# Kansas City Water Works.

Commission of Engineers,

# Report of Commission of Water Works Engineers.

*February 5th, 1902.*

PLAN NO. 9

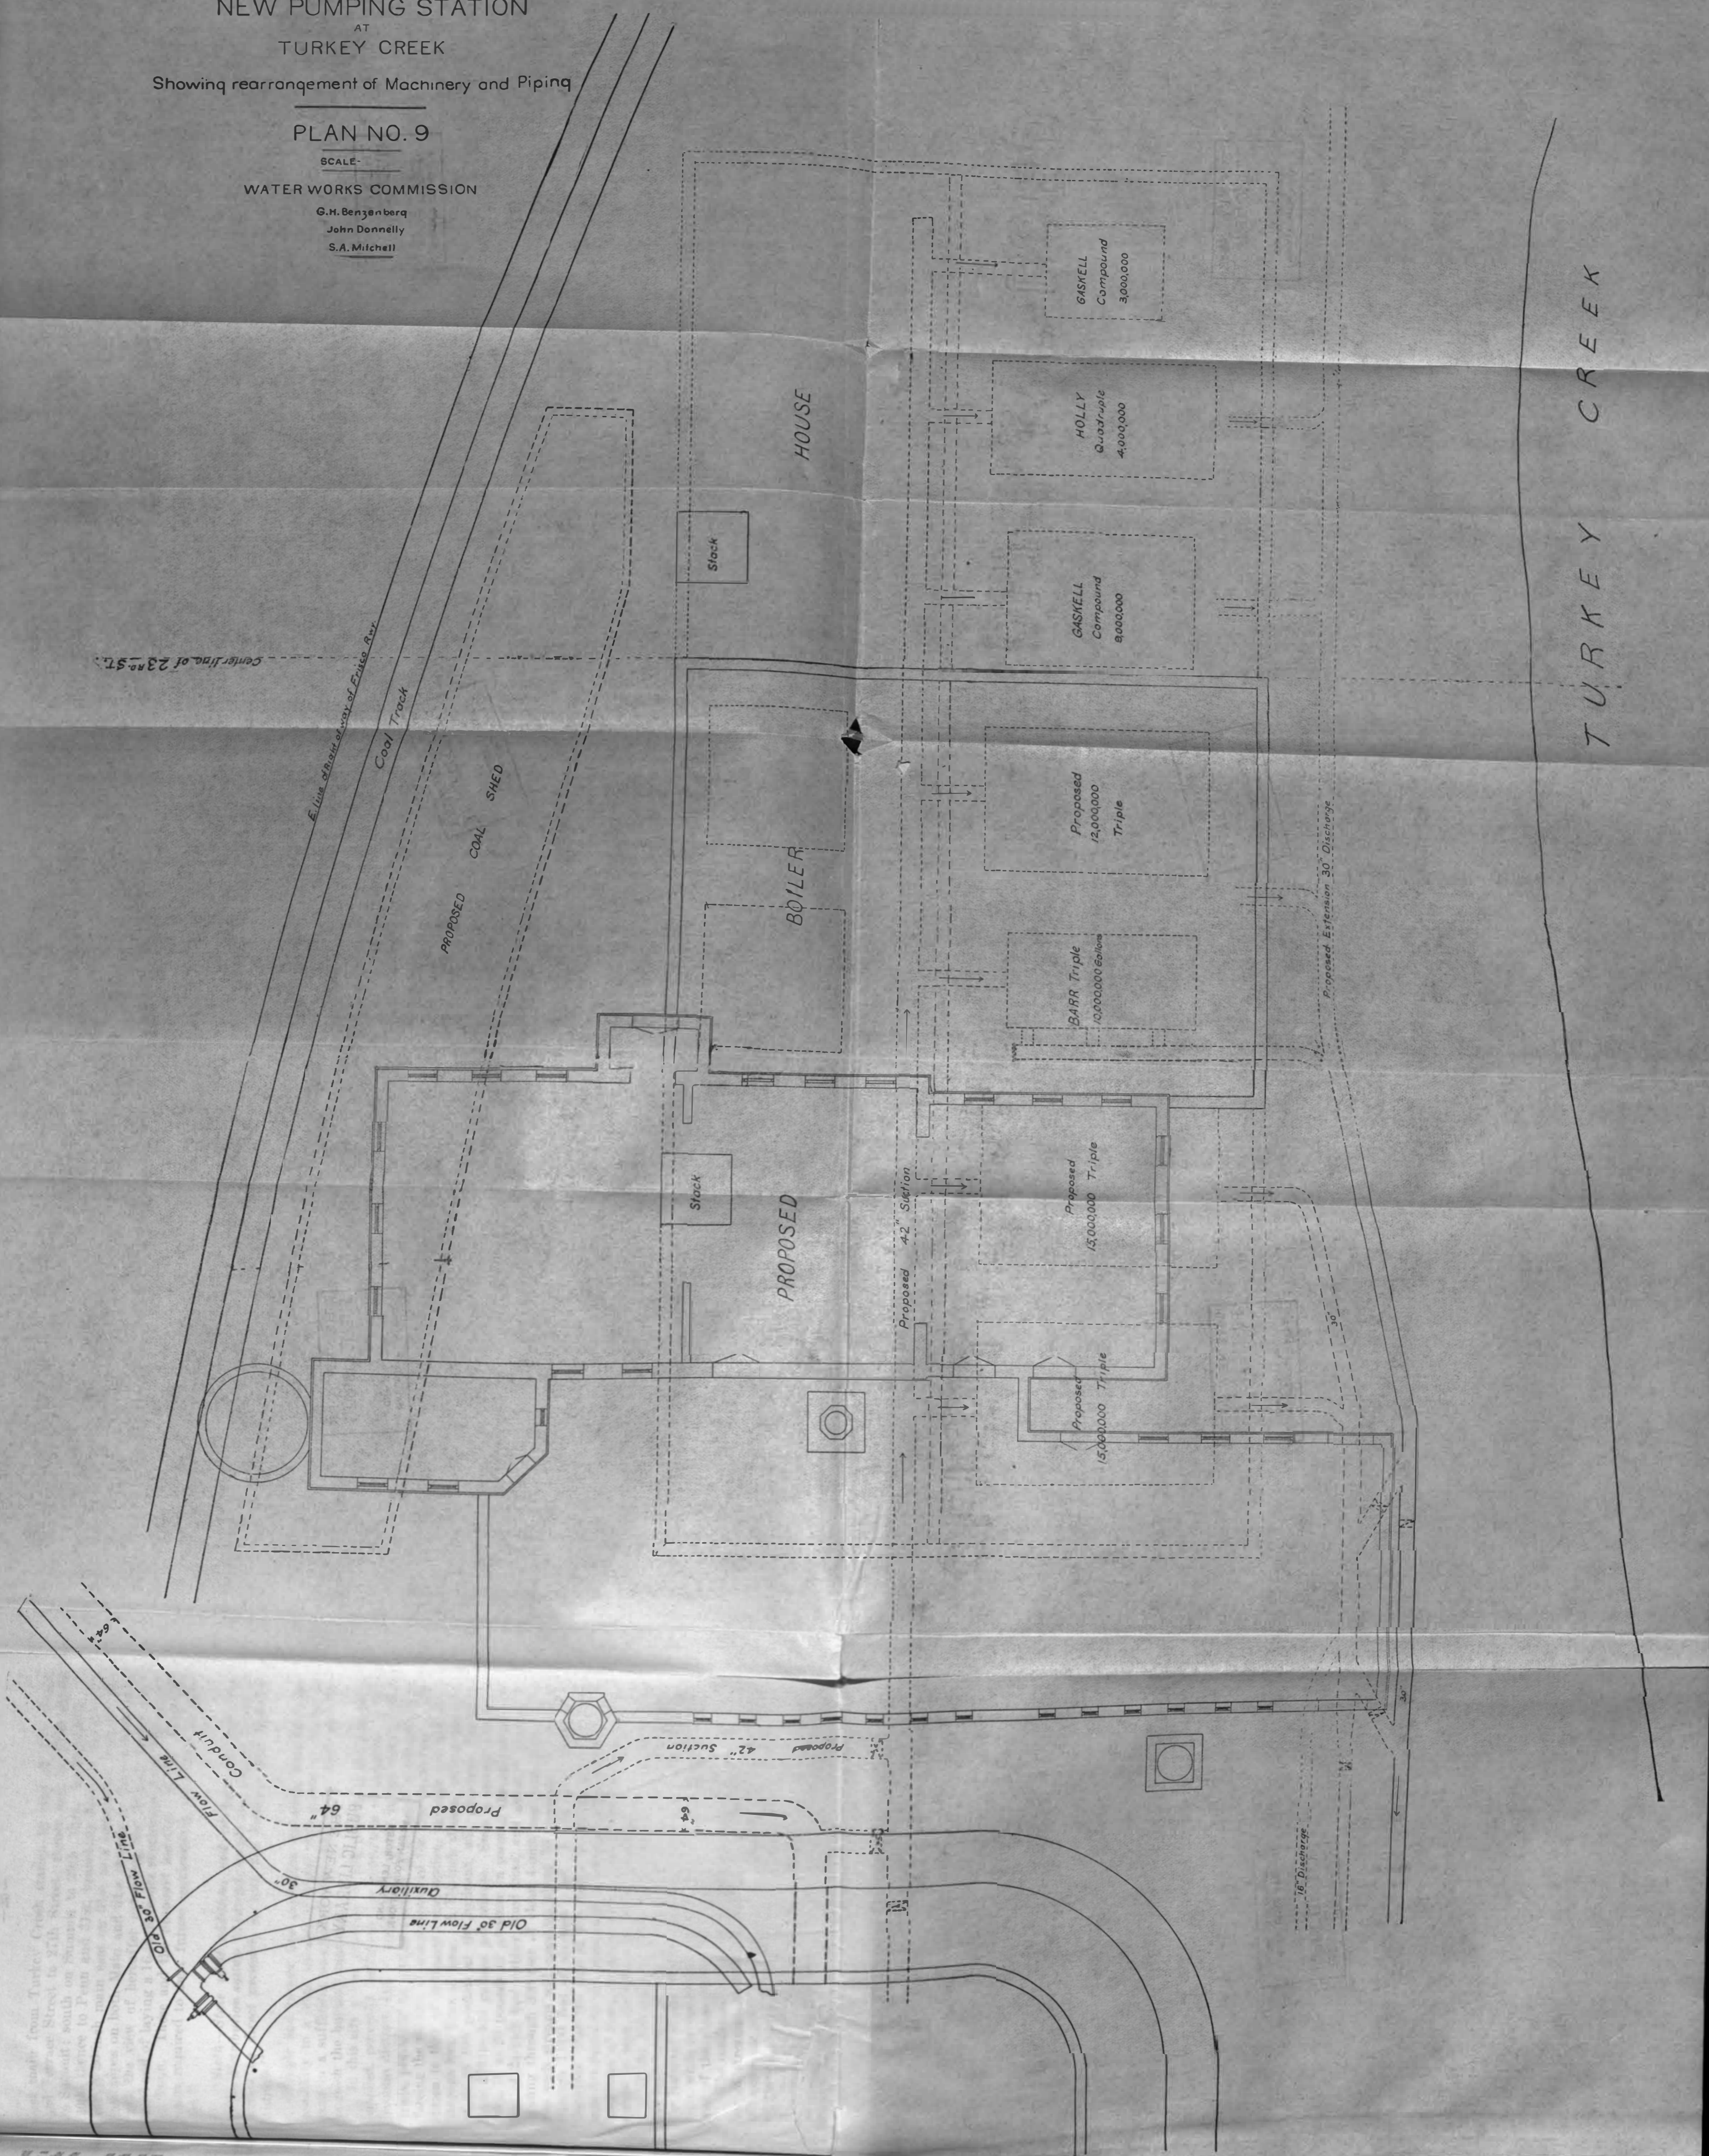
Plan No. 8 submitted with the report, shows the present system, while Plan No. 9, shows the proposed re-arrangement of the station with the location of the present machinery and boilers, when moved, and of the proposed new pumping engines when installed. This arrangement groups the machinery for the low service at the north end and for the high service at the south, with room for extension in both directions for new machinery and boilers when needed in either service. It also provides for coal storage in the rear of the boilers, not now available, with track facilities along side upon city property, which storage can be increased as the works require it.

The plan also shows the re-arrangement of the suction and the discharge mains which now consist of a complicated and intricate system of pipes and specials occupying practically all the available ground around the building and radiating therefrom in every direction. The new system is simple and comprehensive and capable of being extended without change of plan, and we recommend that the work to be done under the re-arrangement consist first in the gradual relocation of these mains as indicated on the plan. This plan can possibly be carried out to meet the requirements of the estimated maximum consumption, within the limits of the land now owned by the City at this station, but it would be most desirable to secure the vacant land for a distance of two hundred and fifty feet north of the water works ground and lying between Brooks Street or Allen Avenue, and the right of way of the St. Louis and San Francisco Railway Company, permitting the new station to be located further north, thus affording more room for extensions hereafter to the south without encroaching upon the basins. This strip of land covers about  $1\frac{1}{2}$  acres, is not used, and is the only ground which can be secured and utilized for extending the works. It is therefore necessary and should be purchased before other use of it is made. The plan prepared contemplates its purchase by the city.

This new machinery should be located in keeping with the proposed re-arrangement and in a section of the new buildings, as shown on plan No. 9. Thereafter new foundations of proper depth and ample strength should be constructed in the new building for the Barr pumping engine as indicated, and this engine overhauled and erected thereon. Like disposition should be gradually made of the four million Holly and the three million Gaskill engines, placing both on the low level service, and also of the high pressure boilers then in service at this station. The 12 million low service Deane pump we suggest to remain where it is until the new conduit is completed and in service.

### PLAN No 2

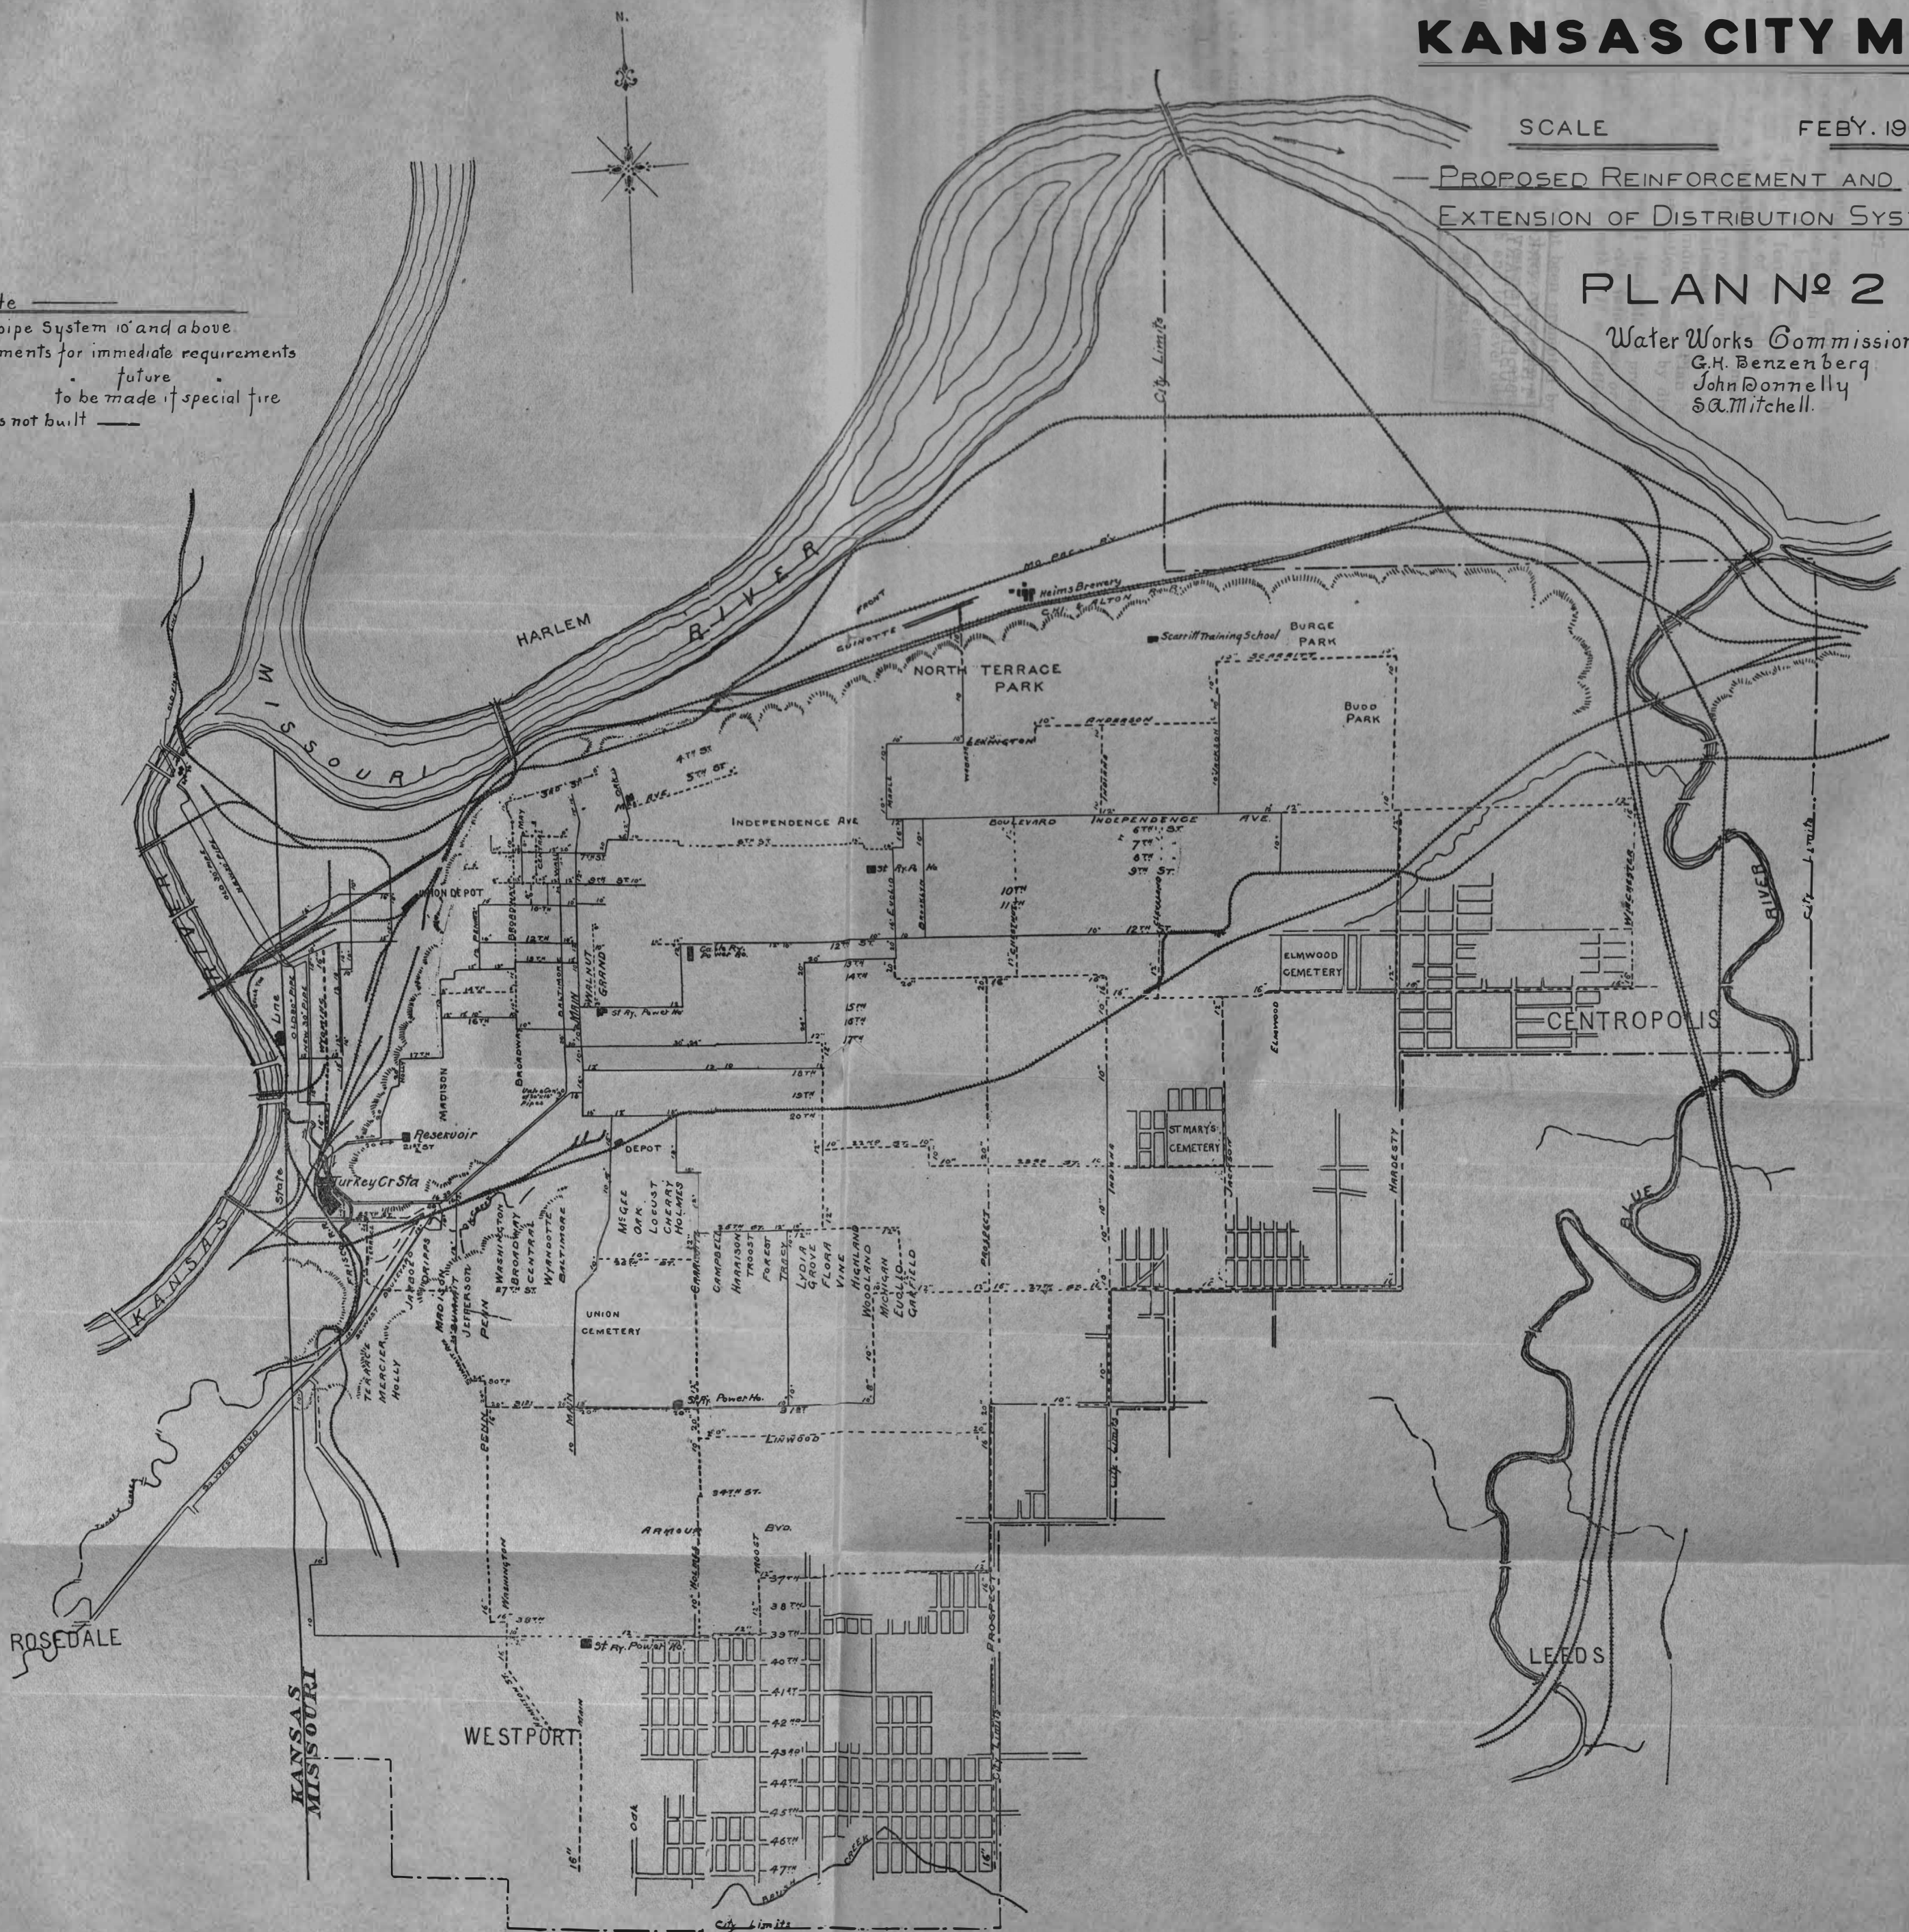
tained in the business sections can be expected in the remote and higher elevated districts, nor is such pressure or number of streams necessary, because the buildings are not as large nor generally more than 40 to 45 feet in height. In districts not above elevation 225 a pressure of 50 pounds at the hydrants can be secured by a liberal system of large mains which will conserve the pressure for fire protection purposes. We, therefore, recommend that in the extension of the distribution system the size of the mains as indicated on Plan No. 2 be followed to provide the best protection possible by direct pressure.

In reply to this question, we would state that it is our opinion that an additional supply for fire purposes could be best secured by the laying of an additional main to the West Bottoms. The size and location of this additional main is shown on Plan No. 2.

PLAN No 10

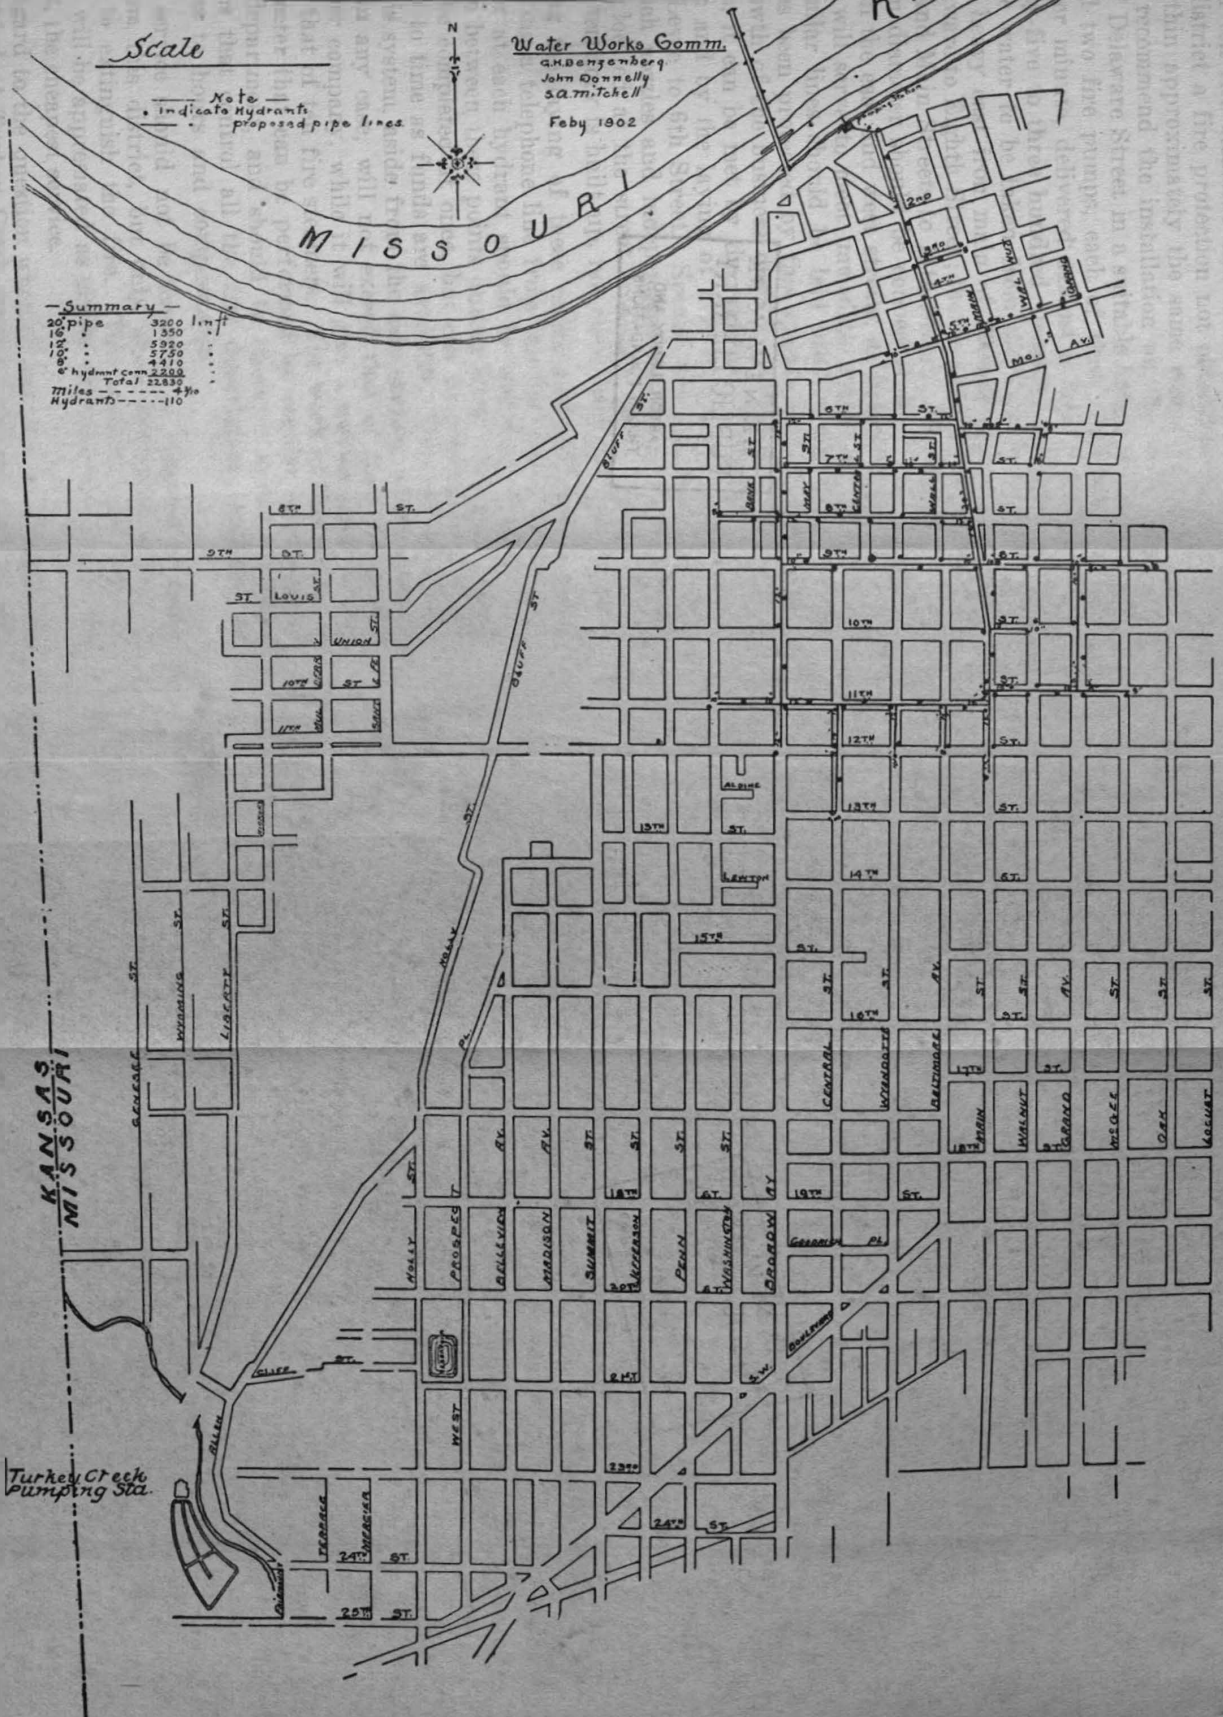
This question contemplates a special direct fire pressure service for the territory outlined with special pumps, water mains, and hydrants exclusively devoted to fire protection.

Two fire pumps of 3,000 gallons per minute capacity each and necessary boilers .....	\$18,000.00
Engine house, foundations and river connection ....	2,500.00
Pipe line as shown on Plan No. 10 .....	52,000.00
110 Special hydrants with their connections .....	7,025.00
1,500 Feet of 3½-inch hose and nozzles .....	2,500.00
Telephone line and boxes .....	3,000.00
Total .....	<u>\$85,025.00</u>
